MODIFICATION BULLETIN NO. LHO-001ISSUED ON Sep. 14, 1994

Model	LHO (MV715)			Date of Modification	
Modified Article				Execution Date	
Reason for Modification	<input type="checkbox"/> Parts catalog correction <input type="checkbox"/> Vendor change	<input type="checkbox"/> To meet standards () <input checked="" type="checkbox"/> Part standardization	<input type="checkbox"/> To facilitate assembly <input type="checkbox"/> To improve reliability <input type="checkbox"/> Other	After the old part has become out of stock.

2. ELECTRICAL SECTION.3 (A120)

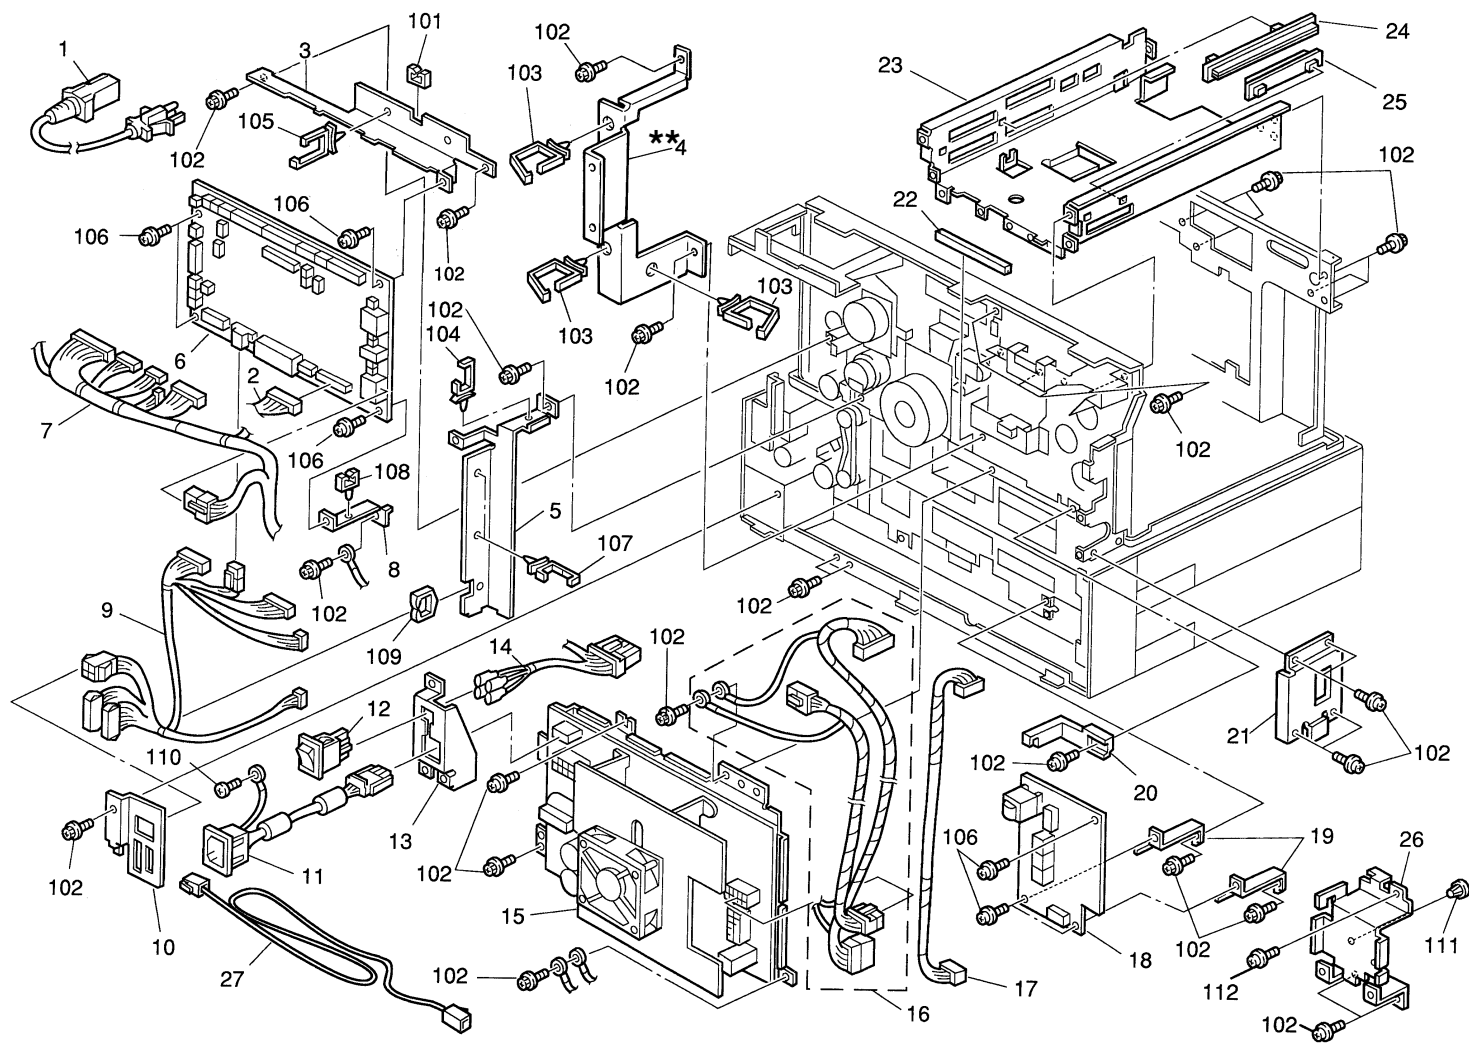
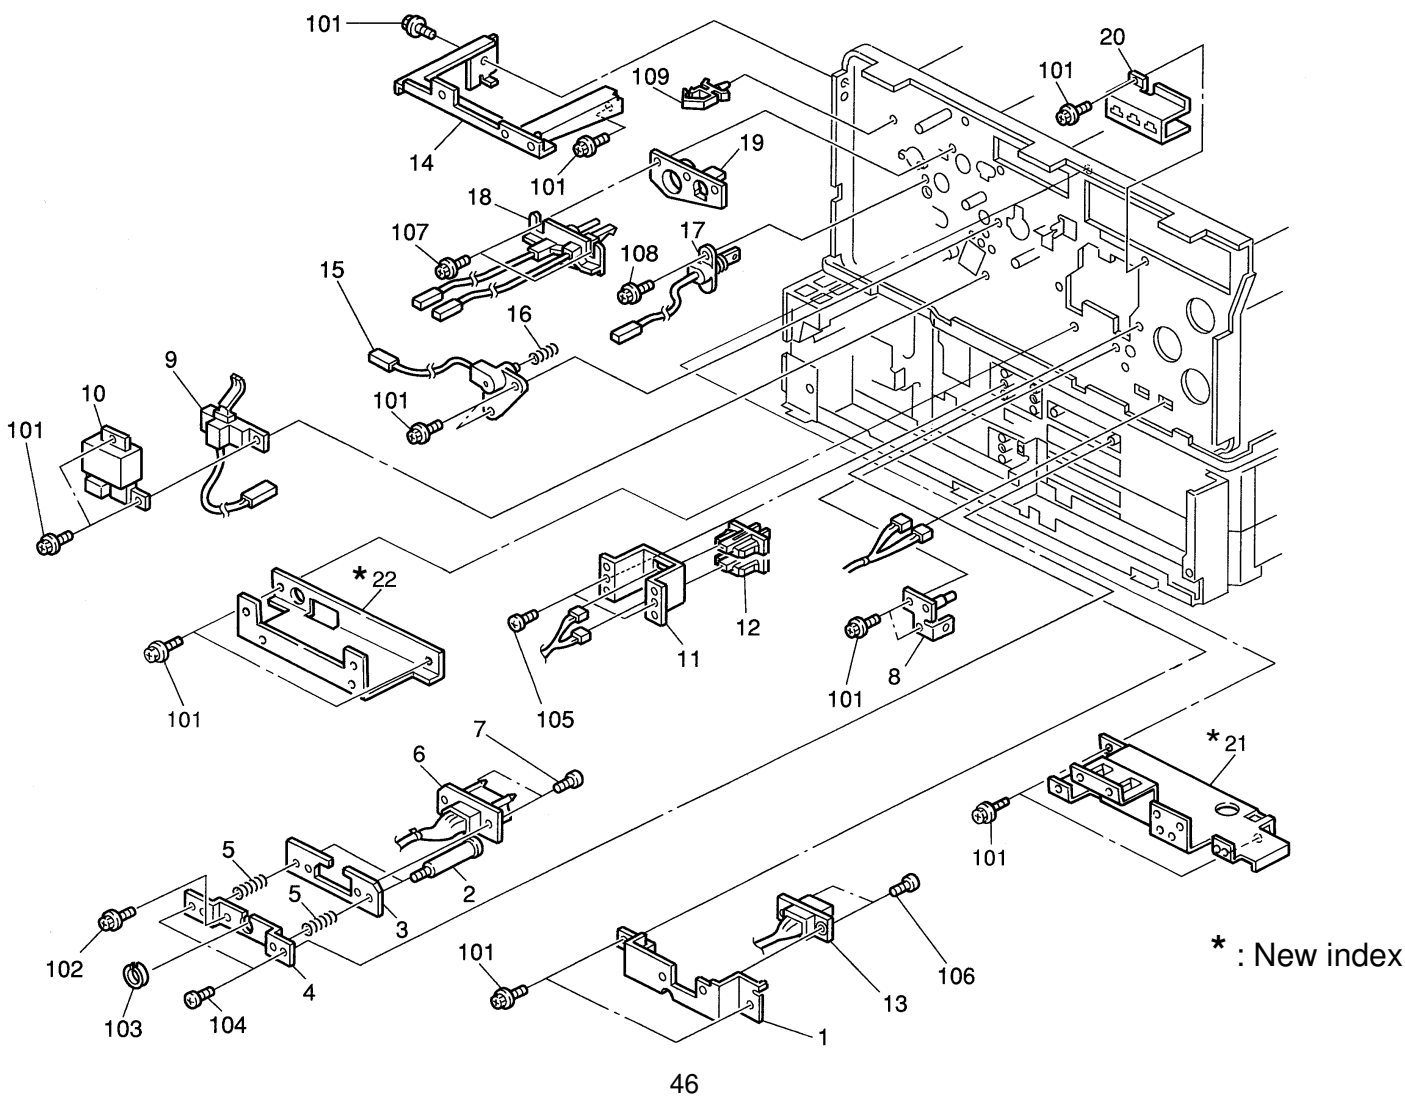
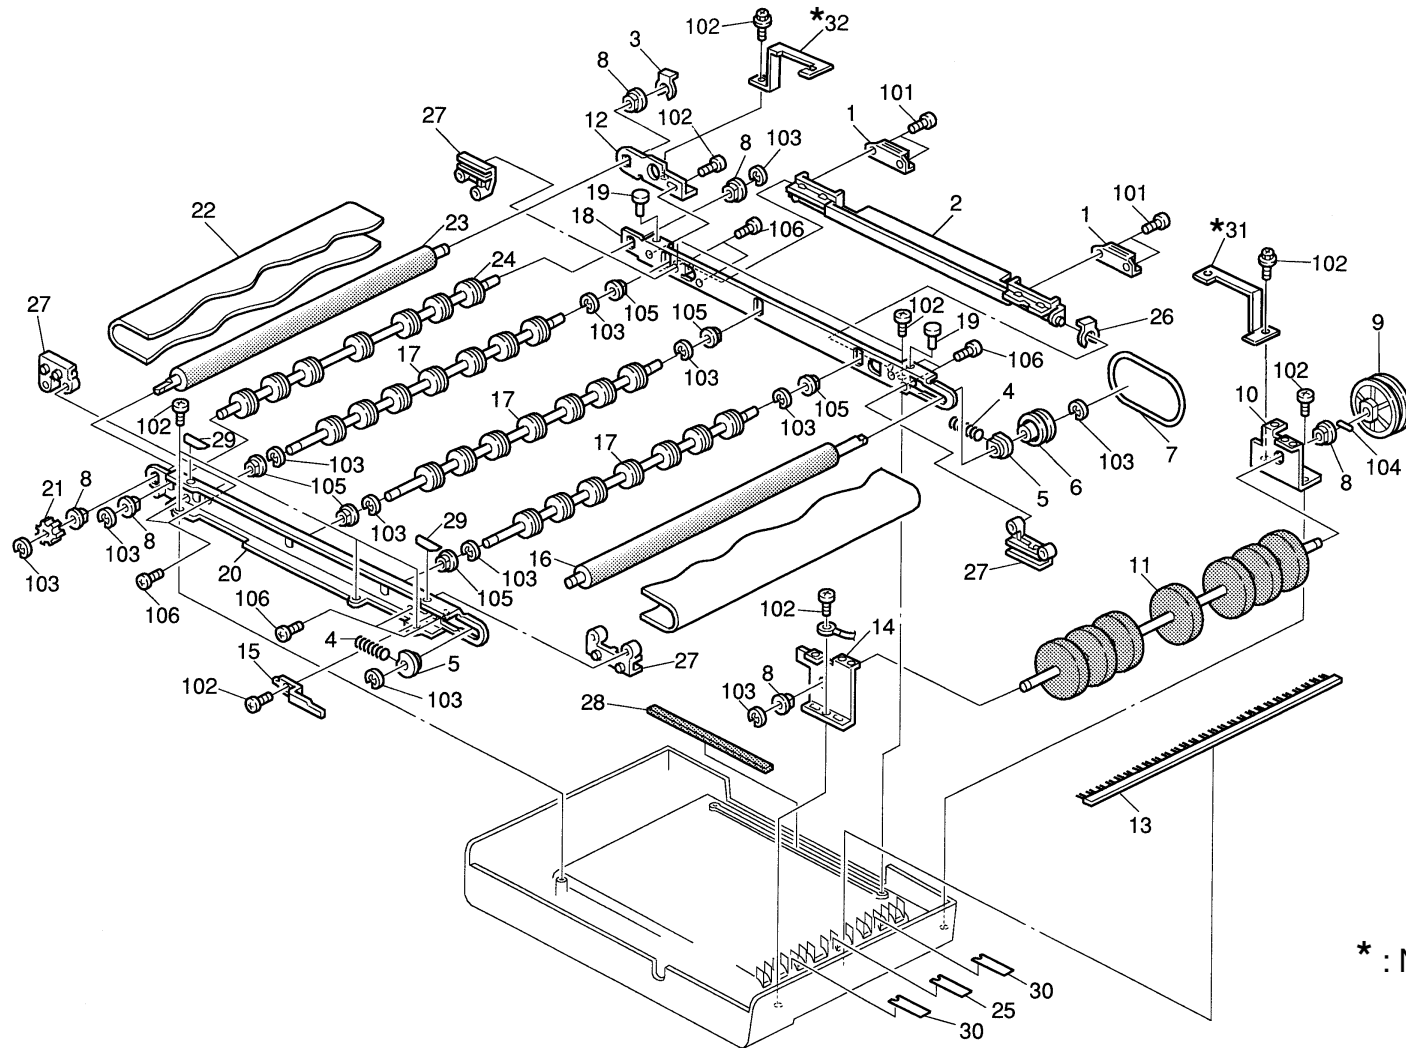
Model	LHO	Date of Modification
Modified Article	LHO Main Frame and ADF	Execution Date
Reason for Modification	<input type="checkbox"/> Parts catalog correction <input type="checkbox"/> To meet standards () <input type="checkbox"/> To facilitate assembly <input type="checkbox"/> Vender change <input type="checkbox"/> Part standardization <input type="checkbox"/> To improve reliability <input checked="" type="checkbox"/> Other	A120-22: 8915020141 A120-27: U8050200001 A120-30: F0650200001 A546-30: W1150200001 (ADF) A546-20: W0950200001 (Sorter)
To meet the Radis Interference Regulation (EN55022 Class B) in Europe, the parts in the table below have been modified. Refer to RTB No.LHO-012 issued on March 15, 1995 for the installation procedure. Note: There is no change to A120-15, -17, and -19 models.

Old Part No.	New Part No.	Description	Q'ty Used Old → New	Interchange-ability	Remarks	Parts Catalog	
						Index No.	Page
H5201115	H5201618	Right Bracket - Operation Panel - 230V	1 → 1	X / O		1	7
H5201114	H5201617	Left Bracket - Operation Panel - 230V	1 → 1			2	7
H5205017	H5205039	Operation Panel Ass'y - 230V	1 → 1	O / O (X / O in Switzerland and Sweden)		3	7
H5201606	H5201625	Scanner Inner Cover - 230V	1 → 1	X / O		2	19
A1001832		Ground Plate - Front	1 → 0			4	19
H5205330	H5205372	Harness - SBU - 230V	1 → 1	O / O (X / O in Switzerland and Sweden)		5	19
H5205304	H5205371	Harness - Optical Unit - 230V	1 → 1			6	19
A1001835		Earth Plate - Frame Rear Left	1 → 0			9	19
A1001834		Earth Plate - Side Rail - Rear Left	1 → 0			10	19

Old Parts No.	New Parts No.	Description	Q'ty Used Old → New	Interchange- ability	Remarks	Parts Catalog	
						Index No.	Page
A1001833		Earth Plate - Side Rail - Rear Right	1 → 0			12	19
A1002116		Harness Holder	1 → 0			14	19
	H5201621	Cover - SBU	0 → 1		*: New Index	*17	19
	16070576	Sleeve Core	0 → 1			*18	19
H5201604	H5201627	Slide Rail - Front - 230W	1 → 1			3	21
A1001801	H5201624	Frame Front - 230V	1 → 1	X / O		9	21
H5201605	H5201628	Slide Rail - Rear - 230W	1 → 1			16	21
A1001837	H5201626	Inner Cover - CCD - 230V	1 → 1			20	21
H5205328	H5205370	Xenon Lamp Harness - 230V	1 → 1	O / O (X / O in Switzerland and Sweden)		21	21
H5201613		Bracket - Stabilizer	1 → 0			31	21
H5201612	H5201116	Cover - Stabilizer - 230W	1 → 1	X / O		34	21
H5205361		Grounding Wire - Rear Left	1 → 0			48	21
H5205360		Grounding Wire - Rear Right	1 → 0			49	21
	H5201619	Ground Plate	0 → 1			*50	21
	H5201620	Film - Slide Rail	0 → 2			*51	21

11050214	H5201117	Spacer - 230V	2 → 2	X / O		107	21
	H5152184	Decal - Warning	0 → 1			*28	35
A1005811	H5202637	Modular Cord Bracket - 230V	1 → 1	X / O		14	37
H5203105		Bracket - Left Rear Cover	1 → 0			15	37
H5203132	H5202639	Bracket - FCU - 230V	2 → 2	X / O		15	41
H5203146	H5202635	Cover - PCB Case - 230V	1 → 1			16	41
H5203135	H5202631	Speaker Bracket	1 → 1			15	43
H5203137		Spacer MBU Support Bracket	1 → 0			16	43

MODIFICATION BULLETIN NO. LHO-025ISSUED ON May 31, 1995DETAILS OF MODIFICATION

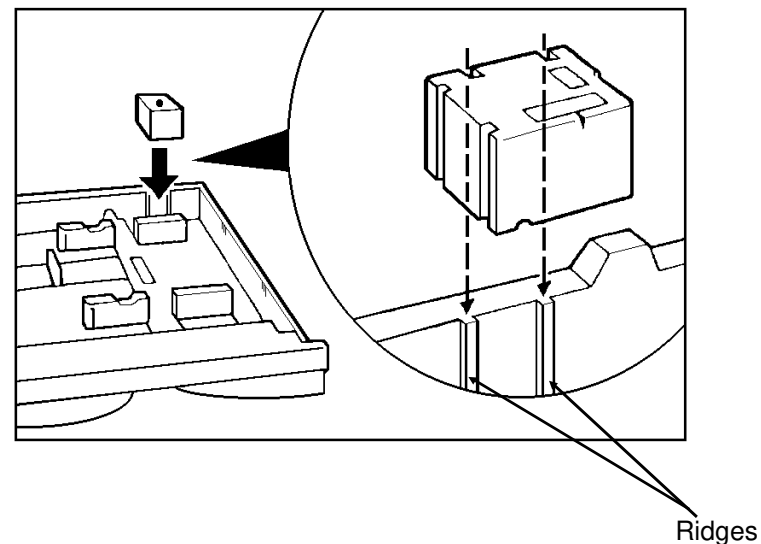
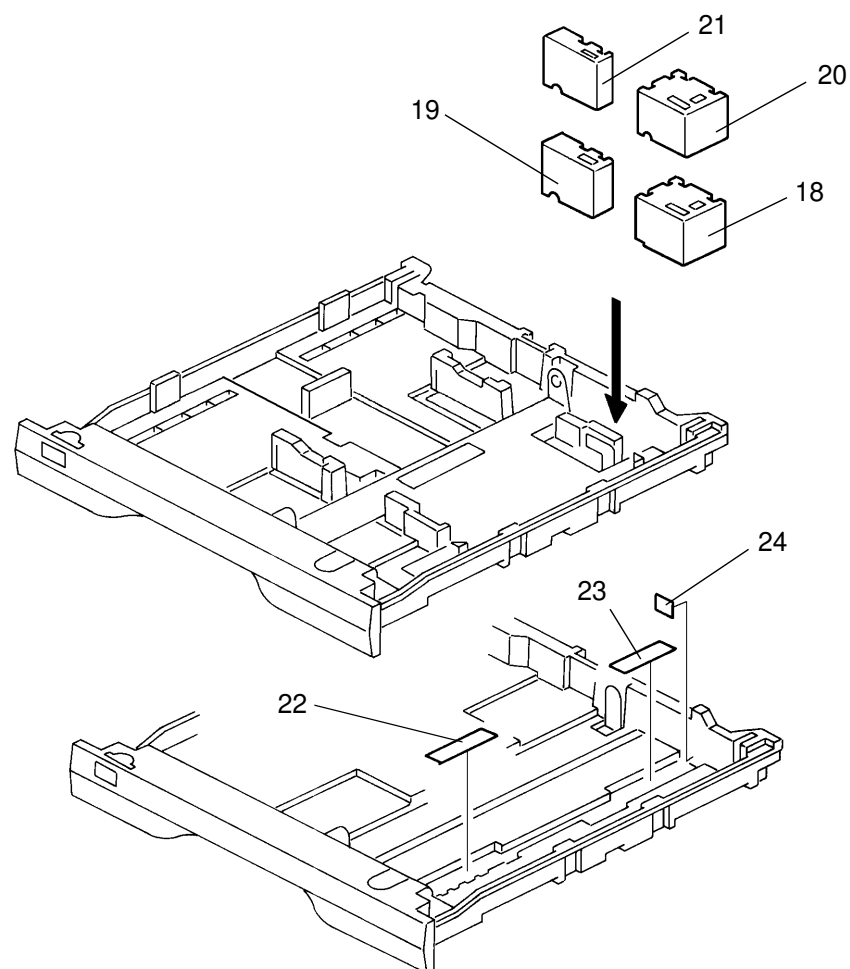
Model	LHO	Date of Modification
Modified Article	Paper trays on the main frame and the paper feed unit	Execution Date
Reason for Modification	<div> <input type="checkbox"/> Parts catalog correction <input type="checkbox"/> To meet standards () <input type="checkbox"/> To facilitate assembly </div> <div> <input type="checkbox"/> Vender change <input type="checkbox"/> Part standardization <input checked="" type="checkbox"/> To improve reliability </div> <div> <input type="checkbox"/> Other </div> <p>To prevent a stack of papers in the paper tray from being out of position from the rear corner separator when the customer closes the paper tray, spacers have been added as accessories (2 sets for the main frame and 1 set for the paper feed unit) and the instruction " • Reinsert the paper tray gently until it stops." has been added to the paper set decal. In addition to this, paper size decals have been newly added to indicate the proper position for the side fences clearly.</p>	Main Frame A120-15: S3050400001 A120-17: M1050400001 A120-19: A19504XXXXX A120-22: 8915040211 A120-27: U8050400001 A120-30: F0650400001 Paper Feed Unit A545-17: M6150400001 A545-27: U3050400001 A545-57: S3150400001

Old Part No.	New Part No.	Description	Q'ty Used Old → New	Interchange- ability	Remarks	Parts Catalog	
						Index No.	Page
	H5202625	Spacer - 8 ¹ / ₂ " X 11" /F	0 → 1		A120-15,-17,-19, A545-17,-57	*18	11, 7
	H5202626	Spacer - 11" X 17"	0 → 1		A120-15,-17, A545-17,-57	*19	11, 7
	A1002678	Spacer - A4 Lengthwise / B5 Lengthwise	0 → 1		A120-19,-22,-27,-30, A545-27	*20	11, 7
	A1002679	Spacer - B4/B5 Sidewise	0 → 1		A120-19,-22,-27,-30, A545-27	*21	11, 7
H5202608	H5202640	Decal - Paper Set - LT	1 → 1	X / X	A120-15,-17,-19, A545-17,-57	2	11, 7
	H5202641	Decal - Paper Set - A4	1 → 1	X / X	A120-22,-27,-30, A545-27	2	11, 7
AF011102	—	Cassette Body	0 → 1	X / O	See note on page 3.	1	11, 7
	H5202642	Decal - Paper Size - LT-Front	0 → 1		A120-15,-17, A545-17,-57	*22	11, 7
	H5202643	Decal - Paper Size - LT-Rear	0 → 1		A120-15,-17, A545-17,-57	*23	11, 7
	H5202644	Decal - Paper Size - A4-Front	0 → 1		A120-22,-27,-30, A545-27	*22	11, 7

Note: To prevent the spacer from being out of position, ridges have been added to the rear fence of the cassette body as shown at the same time. However, its part number (P/N AF011102) has not been changed. It is recommended to use two-sided tape to secure the spacer when it is used for the old cassette body.

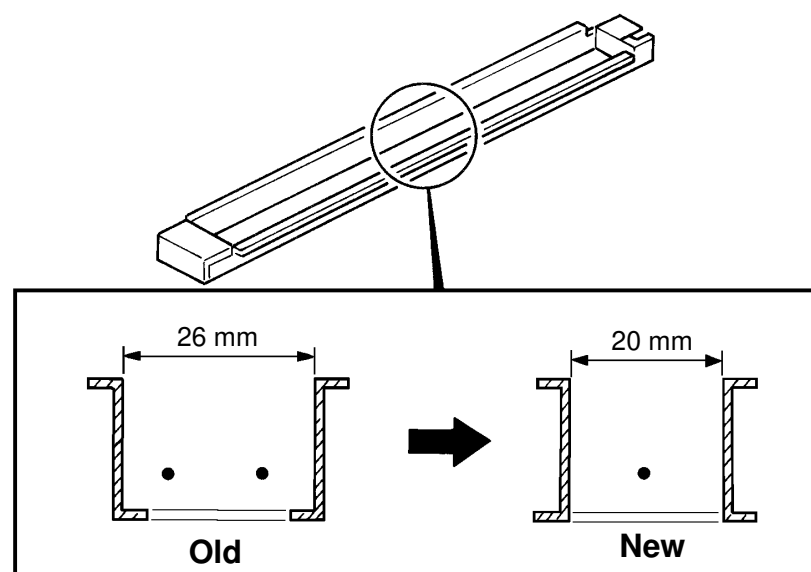
Model	LHO	Date of Modification
Modified Article	Main Corona Unit	Execution Date
Reason for Modification	<div> <input type="checkbox"/> Parts catalog correction <input type="checkbox"/> To meet standards () <input type="checkbox"/> To facilitate assembly </div> <div> <input type="checkbox"/> Vender change <input type="checkbox"/> Part standardization <input checked="" type="checkbox"/> To improve reliability </div> <div> <input type="checkbox"/> Other </div> <p>In order to lessen the occurrence of vertical black lines (zebra stripes) in addition to removing the insulating tape (MB No.LHO-018), the main corona unit has been modified as follows.</p> <ul style="list-style-type: none"> • The number of corona wires has been changed from two to one. • The width between the corona unit casings has been changed from 26 mm to 20 mm. <p>Because of this modification the corona wire cleaner has been modified so that it can be used for both the old and new types of main corona unit.</p>	A120-15: S30506XXXXX A120-17: M1050600001 A120-19: A19506XXXXX A120-22: 8915060328 A120-27: U80506XXXXX A120-30: F0650600001 * In addition to the above, see the attached serial No. List.

Old Part No.	New Part No.	Description	Q'ty Used Old → New	Interchange- ability	Remarks	Parts Catalog	
						Index No.	Page
AD004072	AD004083	Main Corona Unit	1 → 1	X / O		2	29
H5208560	H5208563	Cleaner - Corona Wire	1 → 1	X / O

MODIFICATION BULLETIN NO. LHO-028ISSUED ON Aug. 10, 1995DETAILS OF MODIFICATION

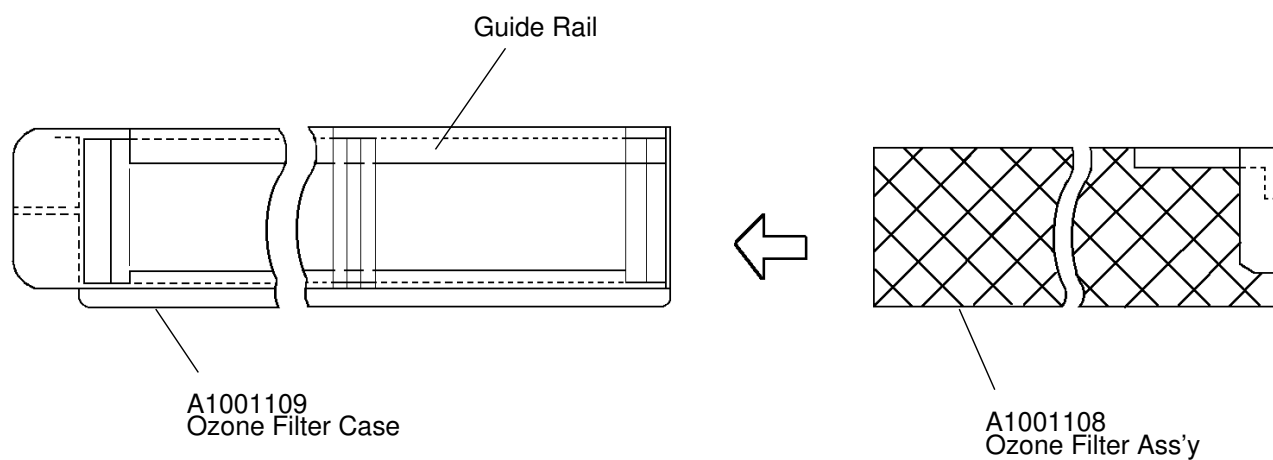
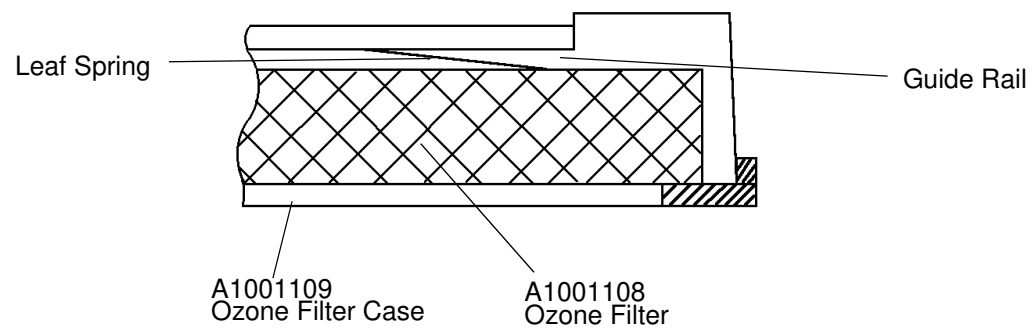
Model	LHO	Date of Modification
Modified Article	Ozone Filter Ass'y	Execution Date
Reason for Modification	<input type="checkbox"/> Parts catalog correction <input type="checkbox"/> To meet standards () <input type="checkbox"/> To facilitate assembly <input type="checkbox"/> Vender change <input type="checkbox"/> Part standardization <input checked="" type="checkbox"/> To improve reliability <input type="checkbox"/> Other To ensure the grounding of the ozone filter a leaf spring has been added to it.	A120-15: S30506XXXXX A120-17: M1050600001 A120-19: A19506XXXXX A120-22: 8915060328 A120-27: U80506XXXXX A120-30: F0650600001 In addition to the above, see the attached serial No. List.

Old Part No.	New Part No.	Description	Q'ty Used Old → New	Interchange- ability	Remarks	Parts Catalog	
						Index No.	Page
AA010078A	A1001108	Ozone Filter Ass'y	1 → 1	X / O		8	27

Note: When the ozone filter is put in the ozone filter case, the leaf spring should be set under the guide rail and should contact it.
